Access Compliance Report

Public Rights-of-Way

(Curb Ramps)

Intersection ID: 22376	Main Street: CREEK_VALLEY_DR	Cross Street: SARDIS_RD	Location: N
ADA ID: FAECE986E7BB	Ramp Type: PerpDiag	Initial Pass/Fail: Fail	Overall Compliance: No
			Severity Score: 33.75

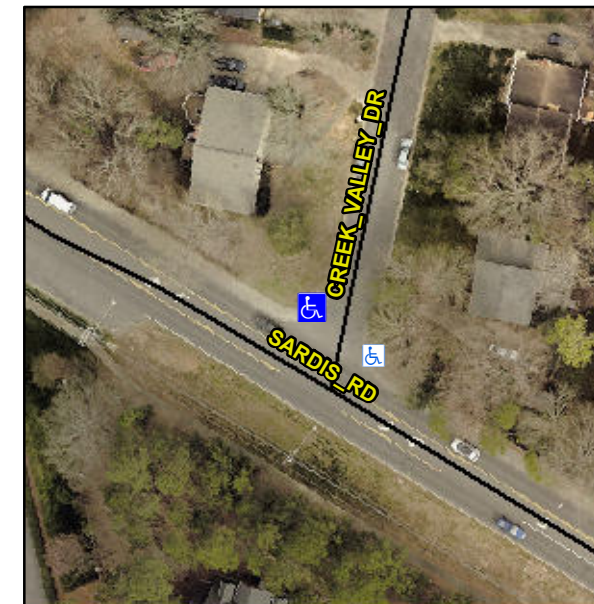
R304.5.1, R304.5.3

Compliance	Description	Data	Compliance	Description	Data
N/A	Ramp Length (in)	59.0	Yes	Ramp Slope (%)	6.9
No	Ramp Width (in)	47.0	No	Ramp XSlope (%)	8.0
N/A	Flare Type LT	N/A	N/A	Flare Type RT	N/A
N/A	Flare Slope LT (%)	N/A	N/A	Flare Slope RT (%)	N/A
N/A	Flare Traversable LT?	N/A	N/A	Flare Traversable RT?	N/A
N/A	Landing Length (in)	N/A	N/A	DWS Provided?	N/A
N/A	Landing Width (in)	N/A	N/A	DWS Contrast?	N/A
N/A	Landing Slope (%)	N/A	N/A	DWS Length (in)	N/A
N/A	Landing X Slope (%)	N/A	N/A	DWS Full Width?	N/A
N/A	Landing Curb? (Y/N)	N/A	N/A	DWS Offset (in)	N/A
N/A	Shared Landing?	N/A			
N/A	Gutter Ponding?	N/A	N/A	Gutter Slope (%)	N/A
N/A	Gutter Lip Ht (in)	N/A	N/A	Gutter X Slope (%)	N/A
N/A	Painted X Walk1?	No	N/A	Painted X Walk2?	No
	X Walk 1 Direction	To SW		X Walk 2 Direction	To SE
N/A	X Walk 1 Width (in)	N/A	N/A	X Walk 2 Width (in)	N/A
	X Walk 1 Slope (%)	5.8		X Walk 2 Slope (%)	4.5
	X Walk 1 X Slope (%)	1.5		X Walk 2 X Slope (%)	8.4

Remove & Replace Curb Ramp With Two New Directional Ramps or Equivalent.
